Rampion 2 Wind Farm

Outline Construction Traffic Management Plan (tracked)

Date: August 2024
Revision G

Document Reference: 7.6
Pursuant to: APFP Regulation 5 (2) (q)
Ecodoc number: 004866600-07

Figure 7.6.6c Local Access Routes

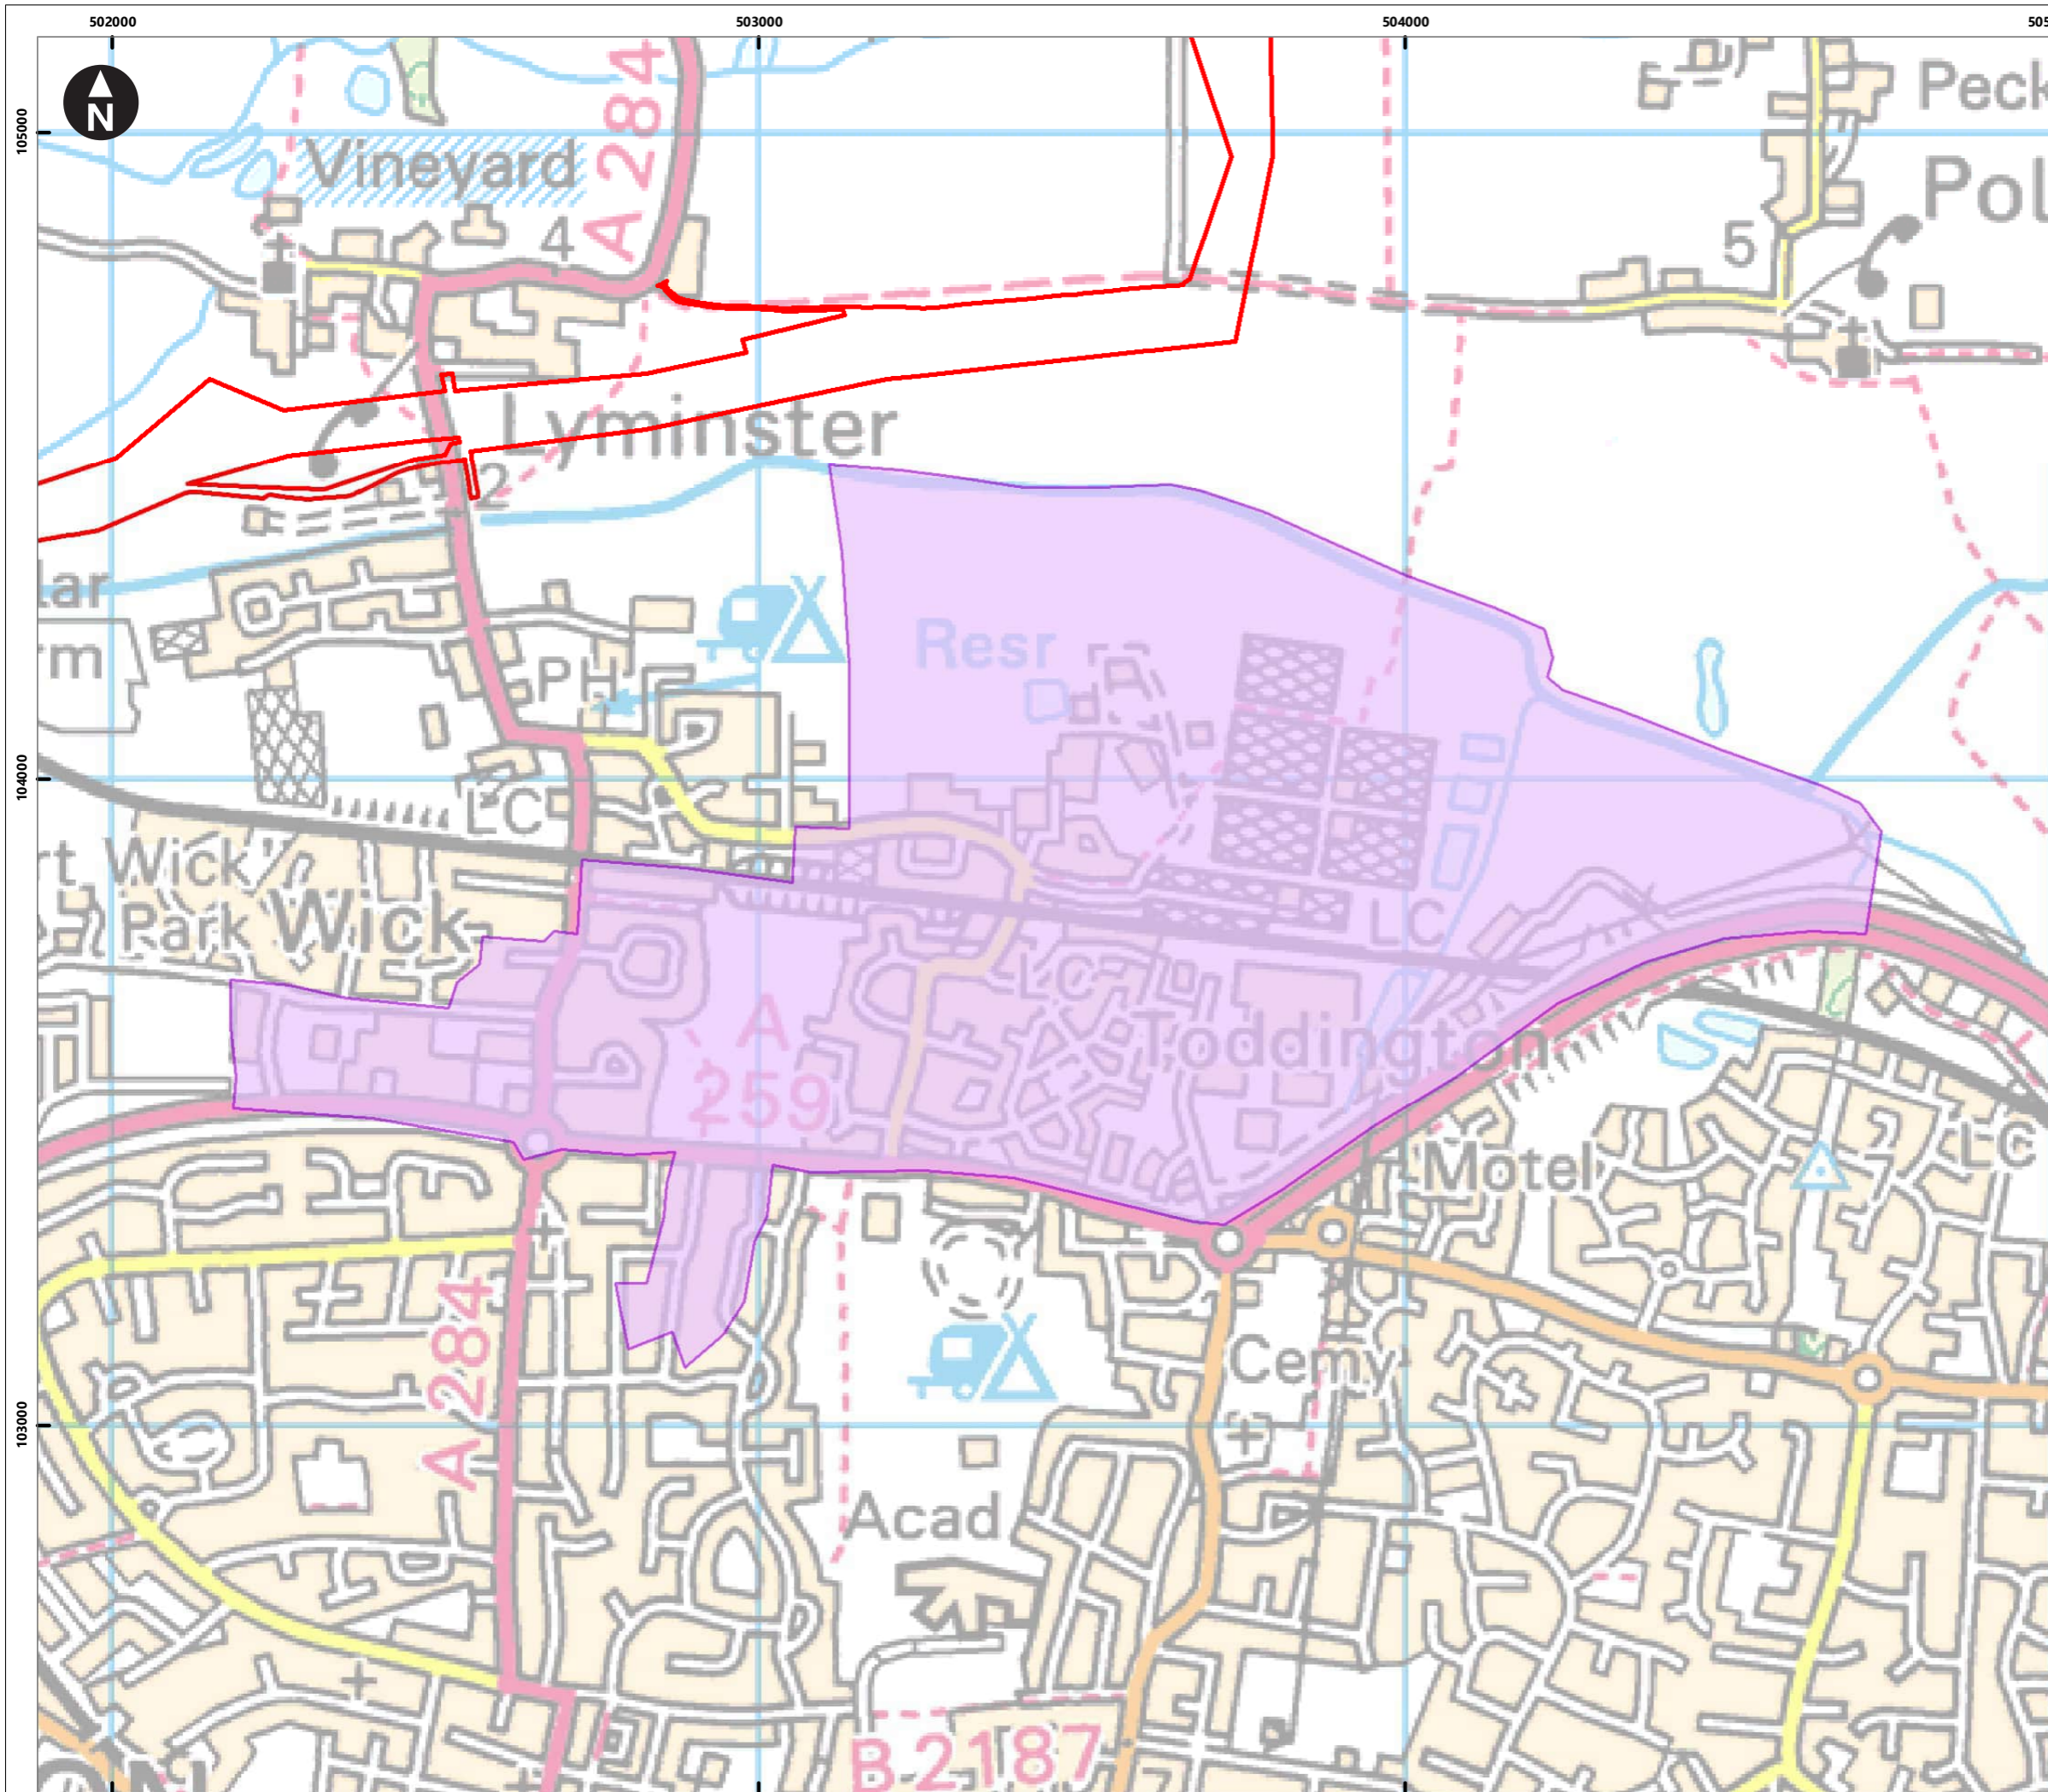
WSCC Local Impact Report Comment	Recommended Action	Applicant’s Response to WSCC Local Impact Report	Applicant’s amendment to the Outline CTMP
<p>Appendix B, Figure 7.6.6c The plan indicates HGV routing along the A272 through Cowfold from the west and using the A281 to the south. Some HGV activity through Cowfold is considered acceptable but in light of the Air Quality Management Area and existing traffic congestion, movements should be restricted. The majority of HGVs should arrive from the A23 to the east.</p>	<p>The plan should be updated to indicate HGV routing through Cowfold only where strictly necessary.</p>	<p>The Applicant will review this request and provide an update to the Outline Construction Traffic Management Plan [REP1-010] at Deadline 3 where appropriate</p>	<p>Additional text added to C-157 and C-158 to state that routing through Cowfold will only be for access A-56 and or A-57 or where use of locally sourced materials / equipment make its avoidance impracticable.</p> <p>In addition, vehicles restrictions are now proposed within Paragraphs 8.4.18 to 8.4.21. These will be implemented through the Delivery Management System and use of bookable delivery slots.</p>
